**ELECTRONIC REPORT TO GEORGES RIVER LOCAL PLANNING PANEL
FOLLOWING DEFERRAL AT 15 NOVEMBER 2018**

LPP Report No	LPP052-18	Development Application No	DA2017/0655
Site Address & Ward Locality	198-200 Princes Highway, Kogarah Bay Kogarah Bay Ward		
Proposed Development	Demolition of existing structures and construction of a 6 storey residential flat building containing twenty-two (22) apartments basement car parking for forty (40) vehicles and associated landscaping and site works.		
Owner	Mr and Mrs Maggos and Mr and Mrs Ping		
Applicant	Shinecorp Kogarah		
Planner/ Architect	Planner: Rod Logan Planning Architect: Geoform and Charles Tang Design		
Date of Lodgement	22/12/2017		
Submissions	Two (2) submissions were received		
Cost of Works	\$6,334,536		
Local Planning Panel Criteria	Residential Flat Building subject to State Environmental Planning Policy No.65		
List of all relevant 4.15(1)(a) matters	Greater Metropolitan Regional Environmental Plan No 2 – Georges River Catchment State Environmental Planning Policy No 55 - Remediation of Land State Environmental Planning Policy (Infrastructure) 2007 State Environmental Planning Policy (Building Sustainability Index: BASIX) 2004 Stat

Figure 2: Minimum sight lines for pedestrian safety

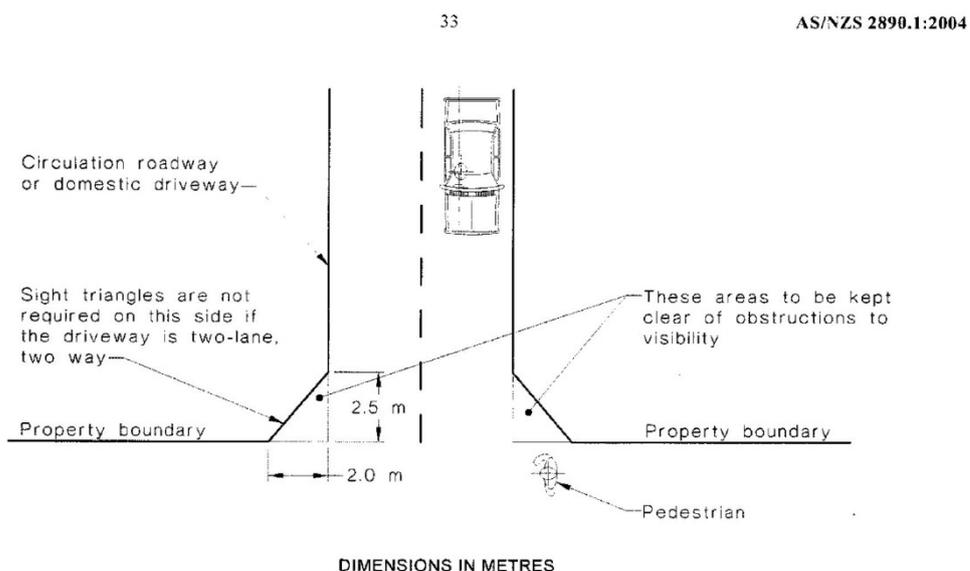
In relation to minimum sight lines to ensure pedestrian safety, Australian Standards specify the minimum sight line requirements which include a minimum 2.5m by 2.0m clearance triangles that are required on both sides of a single lane driveway or just the left (exit) side for a dual width driveway as shown in **Figure 2** below.

The updated assessment states that a condition could be imposed to ensure that fencing for a length of 2.0m adjoining the entry to the driveway along both sides should have a height of 500mm. The proposed fence adjoining the driveway to the north has a height of 1.2m and has been designed to maintain privacy to the front terrace and acts as an acoustic barrier for this private area (refer to **Figure 3** below). This fence is setback approximately 1.5m from the front boundary which will provide for appropriate site distances. Planting in this area is also low scale so it should not adversely affect safety or view lines.

“To ensure pedestrian safety is maintained, the south-western boundary fence adjoining the driveway shall be reduced in height to have a maximum height of 500mm for a length of 2m when measured from the front of the site.”

Figure 4: Extract from Section A-A showing floor to ceiling heights where ducting is for mechanical ventilation is provided.

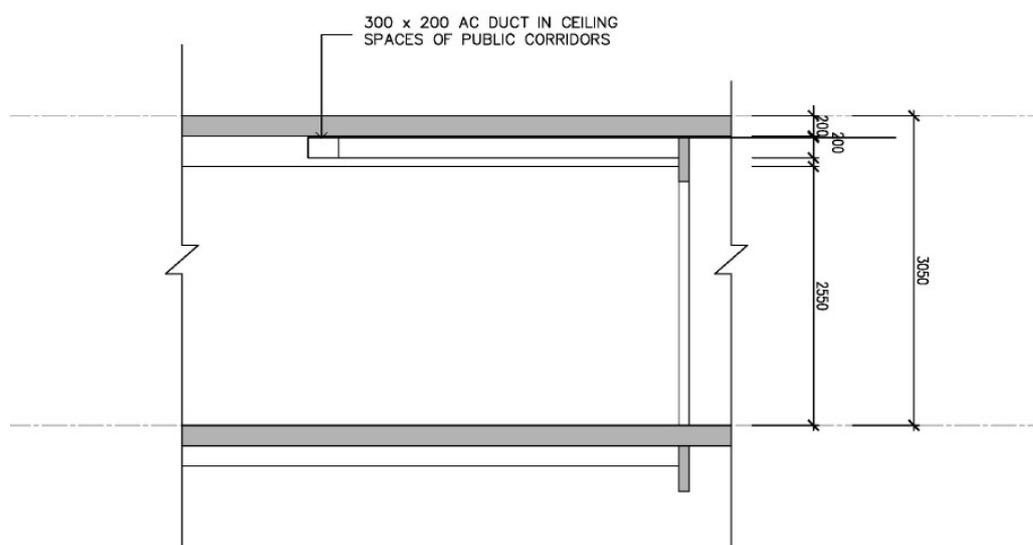
Officer Comment: The Applicant provided additional details and plans prepared by PTC Consulting Engineers which show the location of fire dampers and the location of single and two storey condensers on the roof. The A/C pipe riser on the roof has dimensions of 900 by 400 so well under the other structures on the roof and these units will be below the height limit. The impact of the ducting on the floor to ceiling heights is shown in Section A-A Plan (refer to **Figure 4** below).

The plans also show the ducting arrangement throughout each apartment. Most ducts follow the corridors within each unit and have outlets near the bedroom openings and kitchen areas. These areas will have lower floor to ceiling heights of 2.55m which is acceptable given they are not habitable areas.

The mechanical ventilation that is proposed is considered satisfactory.

Figure 5: South-east elevation showing the amended window opening detail. The design is the same on the north-eastern elevation

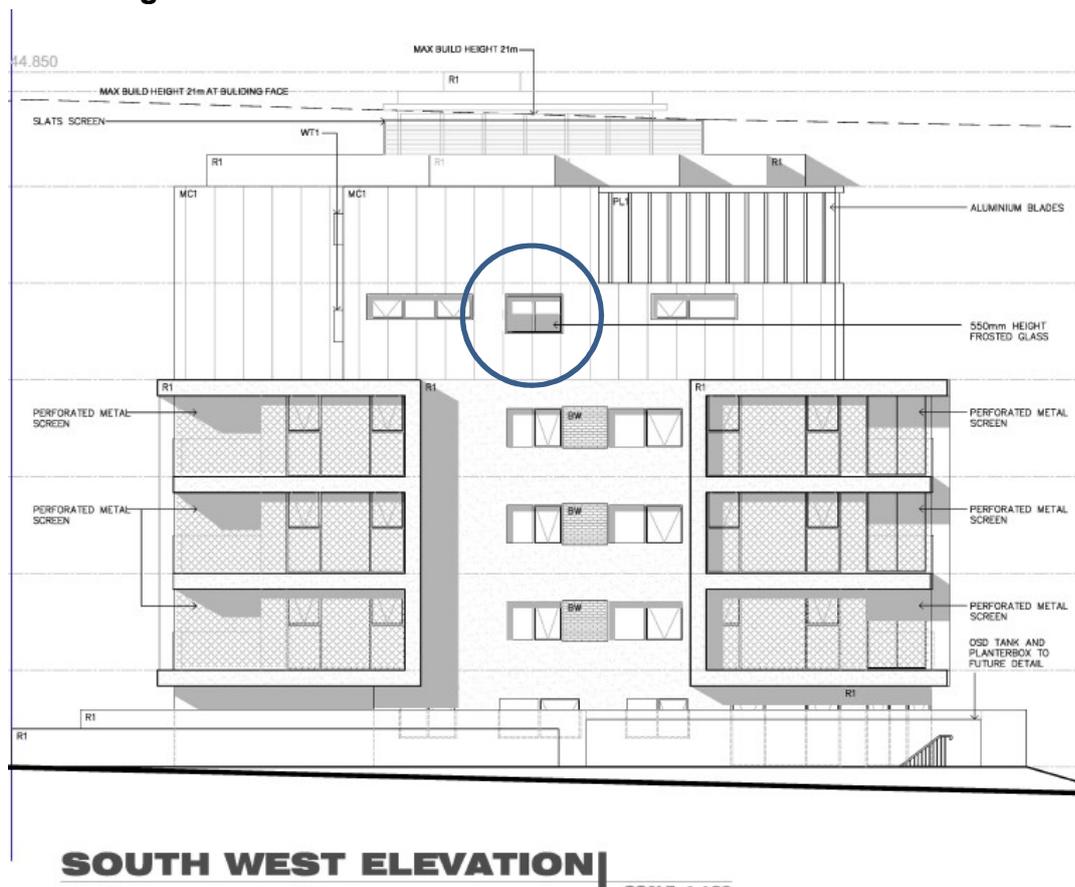
Consistent floor and elevation plans showing the window proposed for Bedroom 2 and any privacy treatment relating to that window in Units 4.02 and 4.03 are to be provided.

Officer Comment: The Applicant has amended and updated the plans so that the elevations are consistent and reflect the floor plans. The design of the original window opening to bedroom No.2 in Units 4.02 and 4.03 was not consistent with the elevations and the Panel requested that this detail be formalised and updated to be consistent on both the elevation and floor plans.

A new set of updated architectural plans have been submitted and Condition No.1 has been updated to reflect these current plans. The plans show on the south-west elevation and north-east elevation that bedroom No.2 to Units 4.02 and 4.03 is a standard window but the bottom 500mm of the window will be constructed of frosted glass (refer to **Figure 5**). This is considered to be an acceptable design solution as a highlight window to a bedroom represents a poor amenity outcome particularly if it is the only opening in the space. A standard sized window will improve the solar access to this space and the frosted element will reduce the potential for any overlooking.
